## 2019 Honda CRF 450 Rx Pinout Change.

On 2019+ Honda CRF 450 Rx models, one wire must be relocated in the ECU connector and two more spliced together. If the RAZE Motorsports ECU is plugged in and these steps are not completed a No Start Condition will occur.

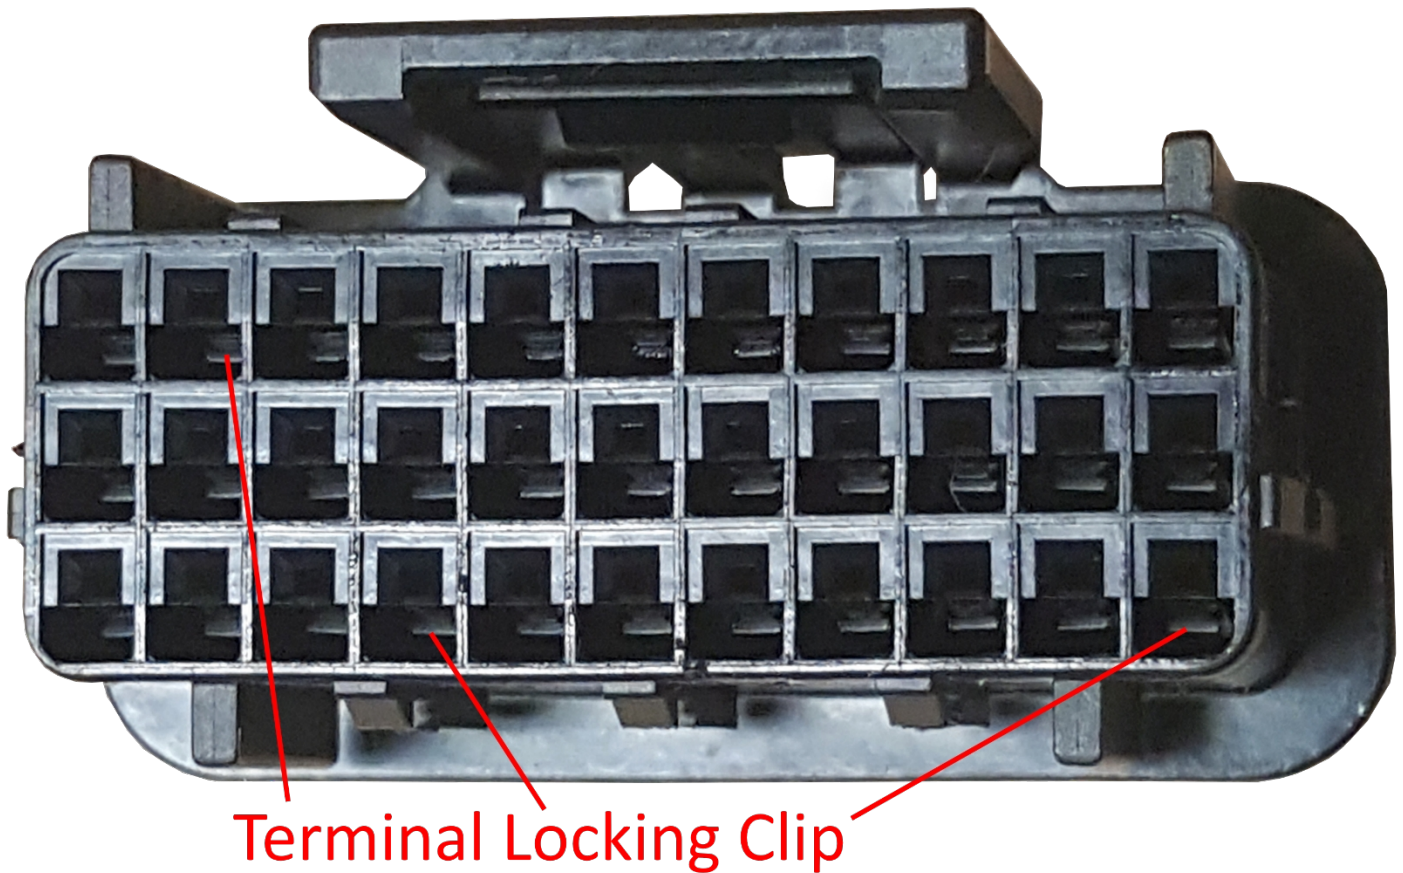
4. Using a small dental pick or automotive pick, release the Terminal Lock for **Pin #9** (Note: image below shows terminal locks).

**Gently** pull the wire, **while holding** the lock away from Terminal, to free Terminal from the ECU connector. Repeat this step for **Pin #32** & **Pin #29**. Make sure to note the Terminal orientation when removing each terminal from the connector housing.

## Wire Entry Side

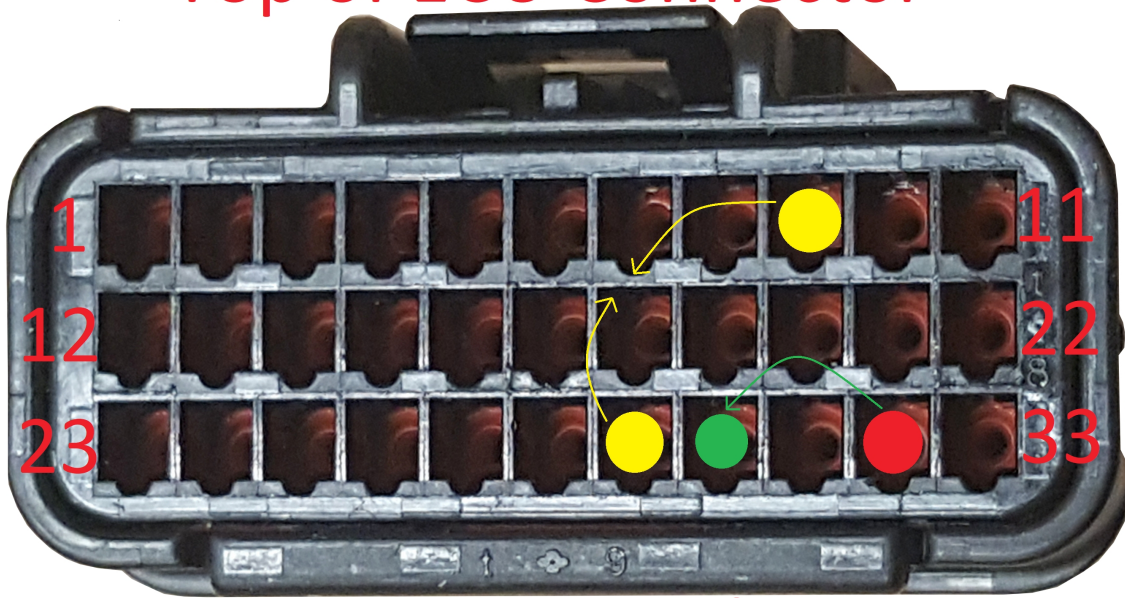
5. On the wire entry side of the ECU connector locate Pin 30 - remove the hole plug from connector and insert the terminal from Pin 32. Make sure Terminal is oriented correctly when inserting it into its new location.
6. On the wire entry side of the ECU connector locate Pin 9 & Pin 29 ( noted in the image above in YELLOW ). Both Pin 9 and 29 must be spliced together.
7. Once Pin 32 is relocated to position 30, inspect to ensure correct orientation and terminal is completely seated. Slide the Terminal Cover back over ECU connector making sure to return it to the locked position on all sides. Harness is now ready to be connected to the RAZE Motorsports Honda CRF ECU.  
Note: reverse steps above if the Honda Factory ECU is to be used.
8. Reconnect Battery Ground to Battery.
